Appendix 1-3: 2004 Everglades Consolidated Report Authors' Responses to Comments

Chapter 2A: Reponses to Peer Review and Public Comments

PEER REVIEW PANEL COMMENTS

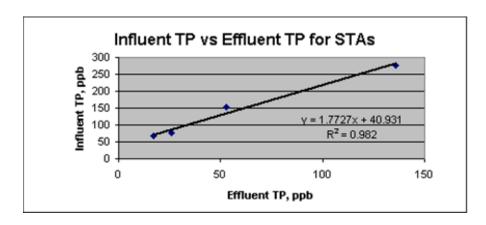
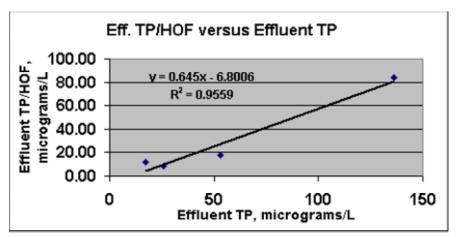
5. All of the STAs were overloaded hydraulically and with TP. How soon, if ever, are the loads to be reduced to the design level?

Response: Although the STAs received greater flows and TP loads than the long-term average annual values anticipated during design, the design contemplated a wide range of inflow values – hence, the STAs were not necessarily overloaded. The exception for WY2003 was STA-1W which received about 3 times the long-term average annual design volume and TP load. Although the flow at the STA-6 inflow pump was about three times the average annual flow used in the design, three factors suggest that it may not have been significantly overloaded:

- a. Not all of the flow measured at this pump station actually passed through the treatment area, but was re-directed for water supply deliveries out of the STA. District staff is presently installing sensors at this location to quantify the water supply deliveries.
- b. Due to lower than expected inflow TP concentrations, the actual TP loading was within 25% of the long-term average used during design.
- c. STA-6 exhibited approximately 80% reduction in TP loads, exceeding the design assumption of 76% reduction.

Operations for STA-1W should be within the design ranges within the next 18 months, coinciding with the anticipated full operation of STA-1 East, scheduled for March 2005. STA-3/4 is scheduled to begin start-up operations in October 2003 with flow-through operations for Cells 1 and 3 commencing in June 2004; this should provide additional operational flexibility for STA-1W and STA-2, particularly with respect to regulatory releases from Lake Okeechobee. Operations for STA-5 and STA-6 should be within the design flow ranges within the next 3 years, coinciding with the anticipated full operation of STA-6 Section 2 (December 2006).
